DART AEROSPACE LTD	Work Order:	107781
Description: Crosstube Assembly, Mid Fwd	Part Number:	D206-667-147
Inspection Dwg: D206-667-147 Rev: A		Page 1 of 2

DRAWING NO. REV. A
D206-667-147 SHEET 1 OF 4

DRAWING NO. D206-667-147	TITLE CROSSTUBE ASS'Y (206L MID FWD)	REV. A	DART AEROSPACE LTD ENGINEERING ORDER		D.E.O. NO. D206-667-147-A-1	SHEET NO. SHEET 1 OF 1	SCALE NTS
DRAWN <i>q</i>	CHECKED <i>ASS</i>	MFG. APPR. <i>JB</i>	APPROVED <i>MD</i>		DE APPR. <i>MD</i>		
DATE 11.07.15	DATE 11.07.20	DATE 11.07.21	DATE 11/07/21		DATE 11.07.21

DRAWING NO. D206-667-147		TITLE CROSSTUBE ASS'Y (206L MID FWD)		REV. A		DART AEROSPACE LTD ENGINEERING ORDER		D.E.O. NO. D206-667-147-A-2		SHEET NO. SHEET 1 OF 1		SCALE NTS	
DRAWN AJS		CHECKED		MFG. APPR. <i>E</i>		APPROVED <i>AP</i>		DE APPR. <i>AP</i>		DATE 12.08.02		DATE 12.08.02	
DATE 12.08.02		DATE 12.08.02		DATE 12.08.02		DATE 12.08.02		DATE 12.08.02		DATE 12.08.02		DATE 12.08.02

DETAIL P
BONDING STRAP INSTALLATION 2 PL

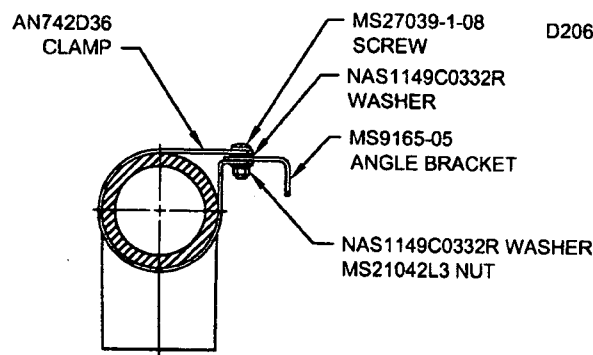
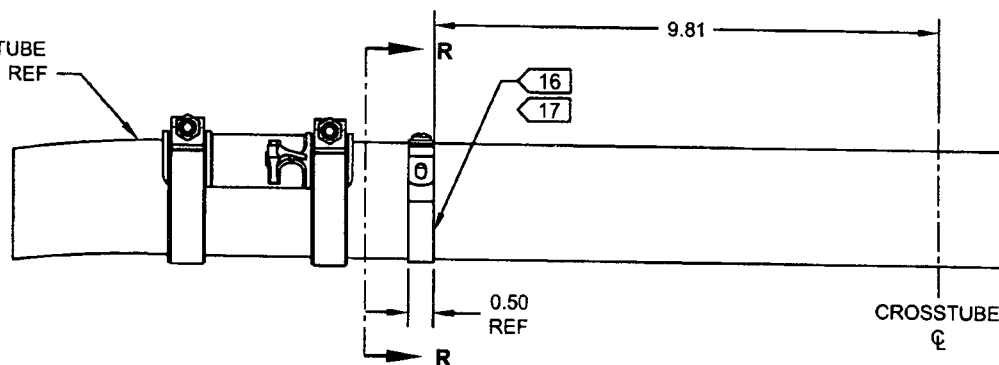
ADD ELECTRICAL GROUNDING STRAP

ADD

- 16) MASK AREA UNDER CLAMP PRIOR TO PAINTING
- 17) SEAL EDGES WHERE AN742D36 CLAMP MEETS WITH THE CROSSTUBE USING SIKAFLEX-241/-291 OR MIL-S-8802 CLASS B2 OR PROSEAL 890 SEALANT
- 18) PERFORM RESISTANCE CHECK TO ENSURE MAX RESISTANCE IS 10 MILLIOHMS

ITEM	QTY -147	PART NUMBER	DESCRIPTION
1	X	D206-667-147	CROSSTUBE ASSEMBLY (206L MID FWD)
10	2	AN742D36	CLAMP
11	2	MS9165-05	ANGLE BRACKET
12	2	MS21042L3	NUT (OR MS21042-3)
13	2	MS27039-1-08	SCREW
14	4	NAS1149C0332R	WASHER (OR AN960C10L)
